SERVICE BULLETIN

N° 139-636

ATA 78 - REAR FIREWALL MODULE ASSY RETROMOD INSTALLATION

This Service Bulletin is issued in order to provide the necessary instruction to perform the installation of rear firewalls module assy retromod P/N 3G7810P02411.

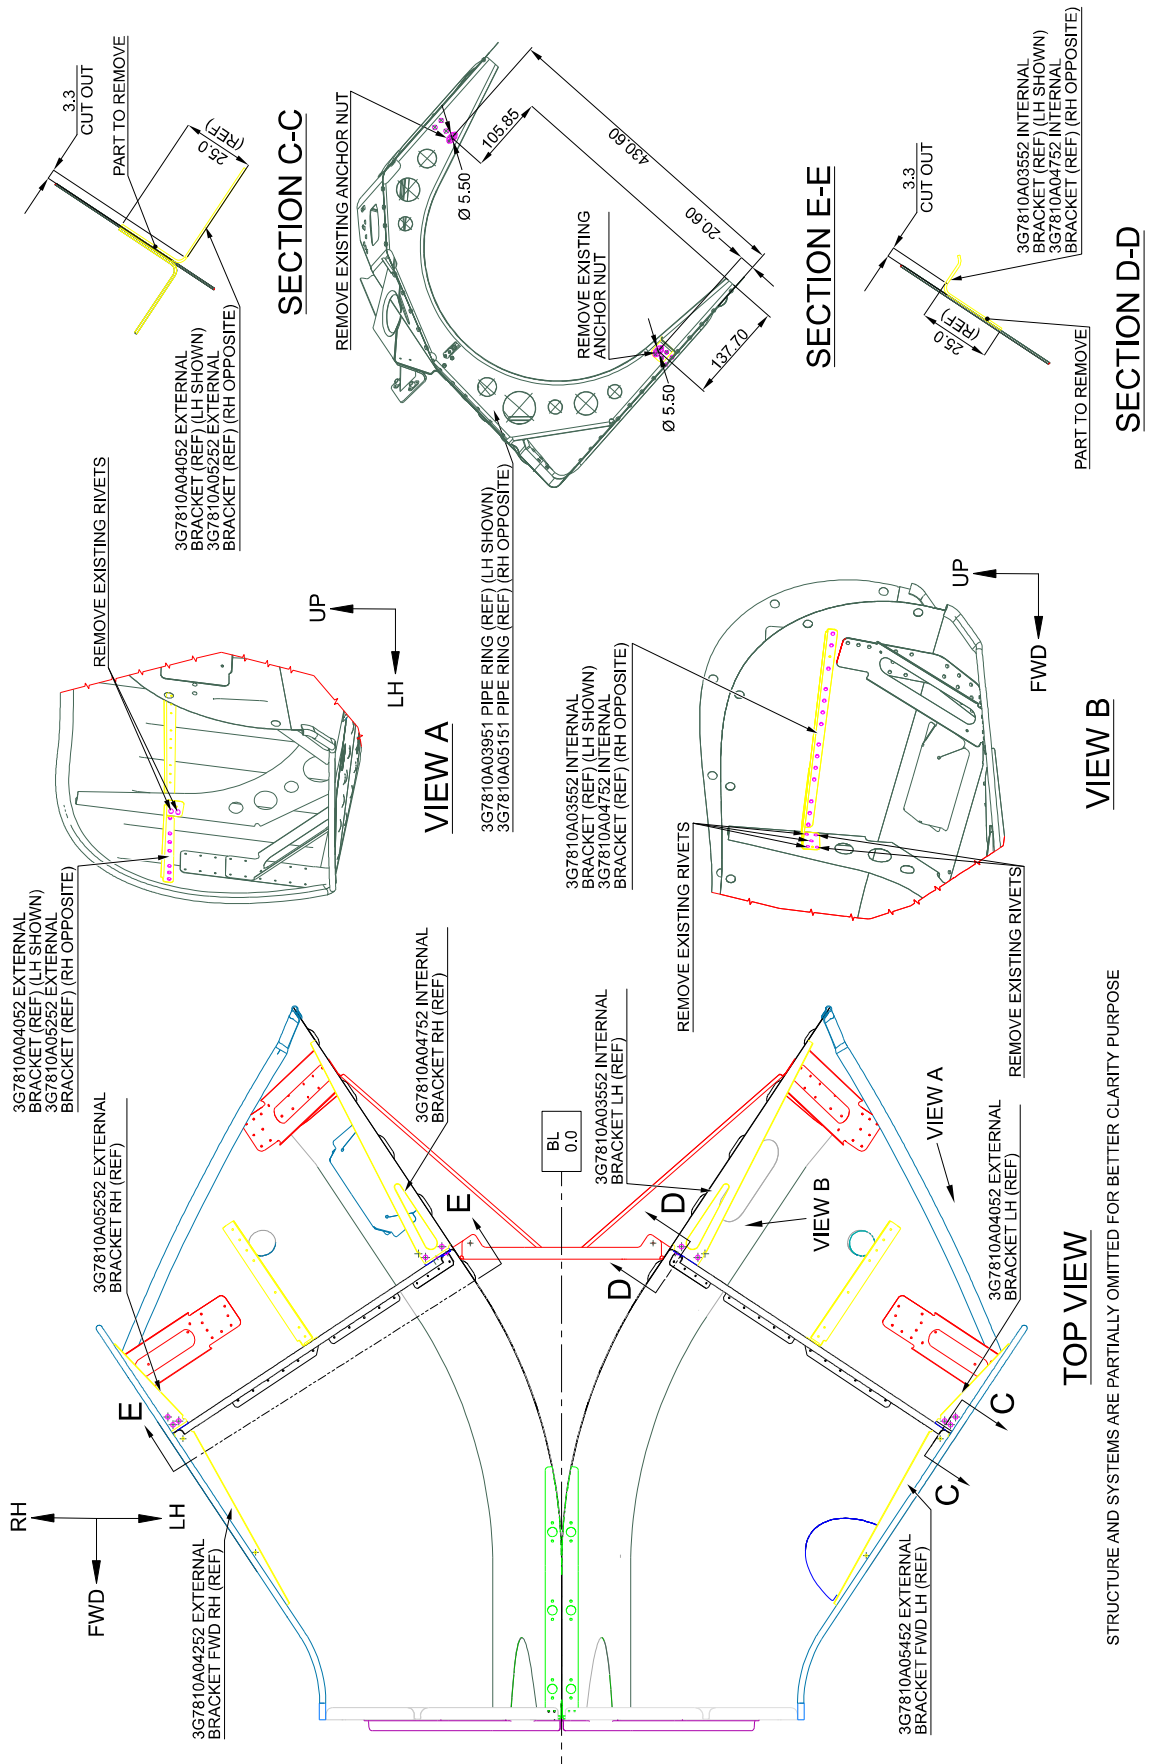
If a repair is already present in the zone indicated in Figure 2 View F and no cracks are present, it is allowed not to install the external bracket LH P/N 3G7810A20051.

- 3.6 With reference to Figure 2 Top View, View F, Section J-J and Section L-L, install the external bracket LH P/N 3G7810A20051 and the plate assy P/N 3G7810A19831 on the external bracket LH P/N 3G7810A04052 and on the pipe ring LH P/N 3G7810A03951 by means of n°5 rivets P/N MS20615-4M4R, n°2 rivets P/N MS20615-4M3R and one of the anchor nut previously removed.

If a repair is already present in the zone indicated in Figure 2 View G and no cracks are present, it is allowed not to install the internal bracket LH P/N 3G7810A20251.

- 3.7 With reference to Figure 2 Top View, View G, Section K-K and Section L-L, install the internal bracket LH P/N 3G7810A20251 and the plate assy P/N 3G7810A19931 on the internal bracket LH P/N 3G7810A03552 and on the pipe ring LH P/N 3G7810A03951 by means of n°5 rivets P/N MS20615-4M4R, n°2 rivets P/N MS20615-4M3R and one of the anchor nut previously removed.

If a repair is already present in the zones indicated in Figure 2 View F and View G and no cracks are present, it is allowed not to install the internal bracket RH P/N 3G7810A20351 and the external bracket RH P/N 3G7810A20451.

- 3.8 Repeat steps 3.6 and 3.7 to install the external bracket RH P/N 3G7810A20451, the internal bracket RH P/N 3G7810A20351, the plate assy P/N 3G7810A19831 and the plate assy P/N 3G7810A19931 on the external bracket RH P/N 3G7810A05252, on the internal bracket RH P/N 3G7810A04752 and on the pipe ring RH P/N 3G7810A05151.

Figure 1

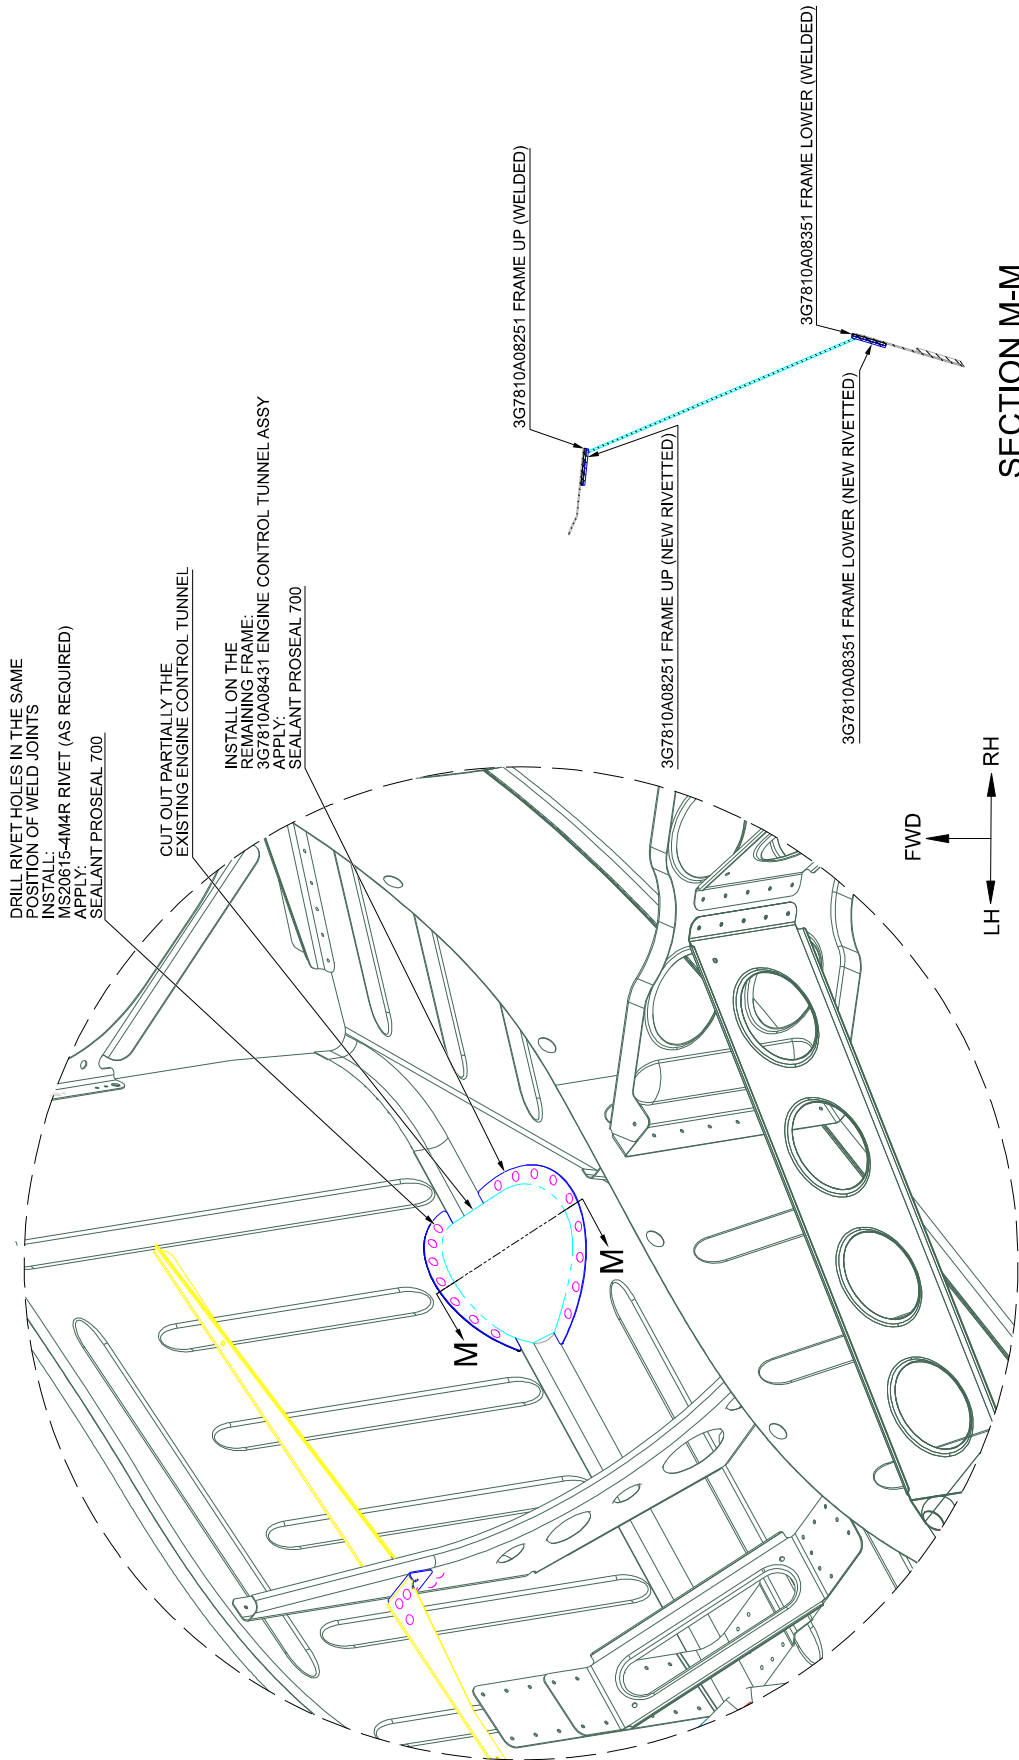
- 3.1 With reference to Figure 1 Top View and View A, remove the existing rivets from the external bracket LH P/N 3G7810A04052.
 - 3.2 With reference to Figure 1 Top View and View B, remove the existing rivets from the internal bracket LH P/N 3G7810A03552.

- 3.3 With reference to Figure 1 Top View and Section C-C, perform the indicated cutout on the external bracket LH P/N 3G7810A04052.
 - 3.4 With reference to Figure 1 Top View and Section D-D, perform the indicated cutout on the internal bracket LH P/N 3G7810A03552.

- 3.5 With reference to Figure 1 Top View and Section E-E, remove and retain for later use the n°2 anchor nuts from the pipe ring LH P/N 3G7810A03951.

4. With reference to Figure 1, remark the reworked rear firewalls module assy as P/N 3G7810P02411.
5. In accordance with AMP DM 39-A-06-41-00-00A-010A-A, install the access panels 480AL and 480AR.

Figure 4

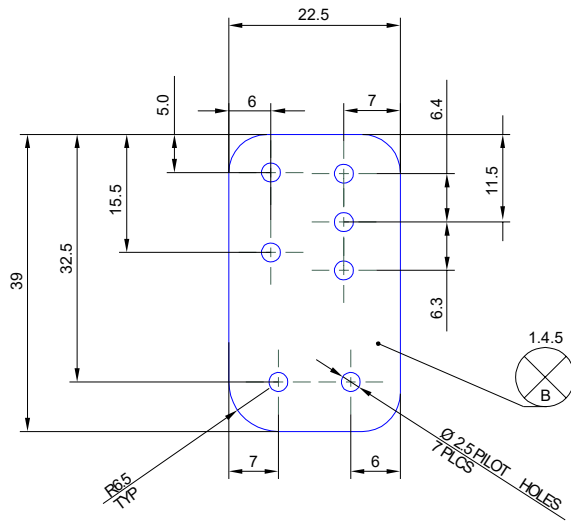
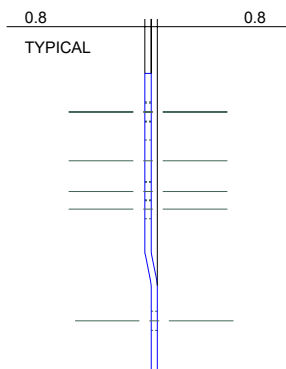
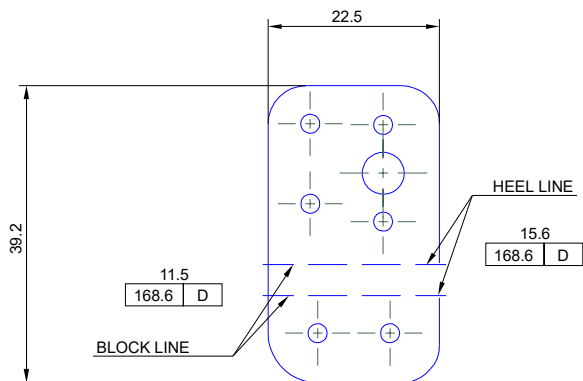
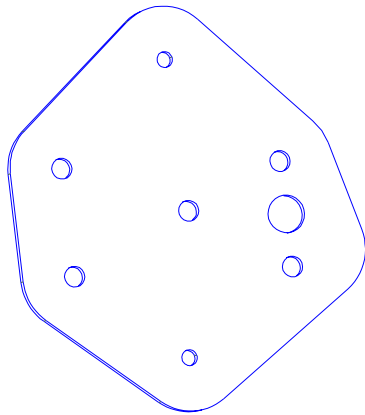
If P/N 3G7810A19831 doesn't fit with the structure due to the presence of a repair, it is possible to fabricate the plate from raw materials in order to make it fits with the repaired structure (refer to Figure 4). Dimensions in the figure are for reference, it is possible to adjust these dimensions to be compliant with standard practices contained in DM CSRPA-51-71-00-00A-028A-D.

Figure 5

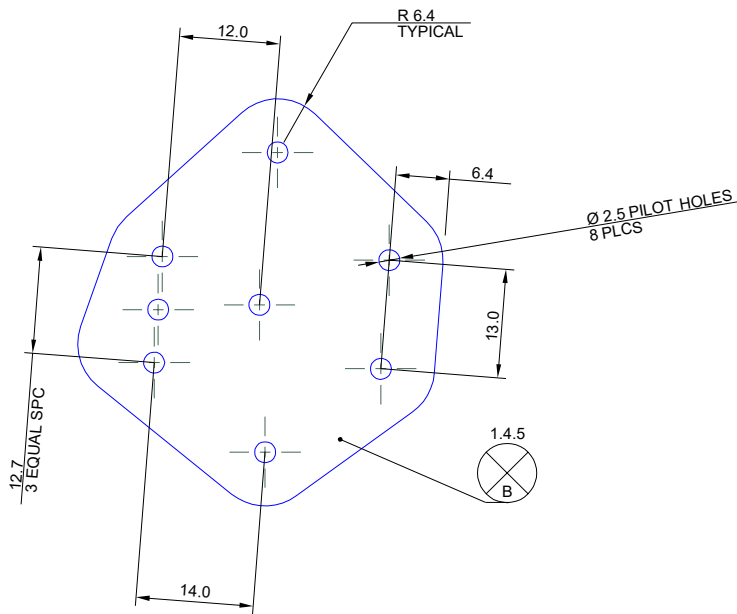
If P/N 3G7810A19931 doesn't fit with the structure due to the presence of a repair, it is possible to fabricate the plate from raw materials in order to make it fits with the repaired structure (refer to Figure 5). Dimensions in the figure are for reference, it is possible to adjust these dimensions to be compliant with standard practices contained in DM CSRPA-51-71-00-00A-028A-D.
